Access Compliance Report

Public Rights-of-Way

Intersection ID: 27048	Main Street: PIPER_GLEN_DR	Cross Street: VERSAILLES_LN	Location: NW
ADA ID: 6104282F5E03	Ramp Type: PerpDiag	Initial Pass/Fail: Fail	Overall Compliance: No
Severity Score: 12.5			
Codes/Mitigation Info/Possible Solution		Field Measurements/Component Compliance

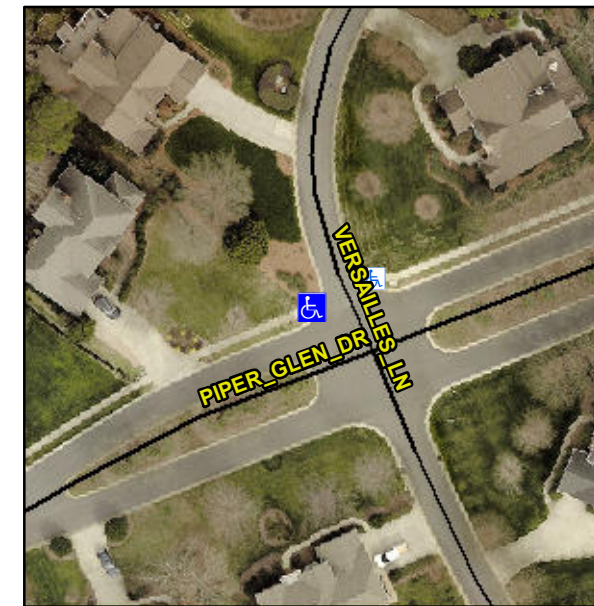
R304.5.3

Compliance	Description	Data	Compliance	Description	Data
N/A	Ramp Length (in)	96.0	Yes	Ramp Slope (%)	5.6
Yes	Ramp Width (in)	62.0	No	Ramp XSlope (%)	5.1
N/A	Flare Type LT	N/A	N/A	Flare Type RT	N/A
N/A	Flare Slope LT (%)	N/A	N/A	Flare Slope RT (%)	N/A
N/A	Flare Traversable LT?	N/A	N/A	Flare Traversable RT?	N/A
N/A	Landing Length (in)	N/A	N/A	DWS Provided?	N/A
N/A	Landing Width (in)	N/A	N/A	DWS Contrast?	N/A
N/A	Landing Slope (%)	N/A	N/A	DWS Length (in)	N/A
N/A	Landing X Slope (%)	N/A	N/A	DWS Full Width?	N/A
N/A	Landing Curb? (Y/N)	N/A	N/A	DWS Offset (in)	N/A
N/A	Shared Landing?	N/A			
N/A	Gutter Ponding?	N/A	N/A	Gutter Slope (%)	N/A
N/A	Gutter Lip Ht (in)	N/A	N/A	Gutter X Slope (%)	N/A
N/A	Painted X Walk1?	No	N/A	Painted X Walk2?	No
	X Walk 1 Direction	To SE		X Walk 2 Direction	To NE
N/A	X Walk 1 Width (in)	N/A	N/A	X Walk 2 Width (in)	N/A
	X Walk 1 Slope (%)	9.7		X Walk 2 Slope (%)	2.1
	X Walk 1 X Slope (%)	1.1		X Walk 2 X Slope (%)	5.4

Remove & Replace Curb Ramp With Two New Directional Ramps or Equivalent.
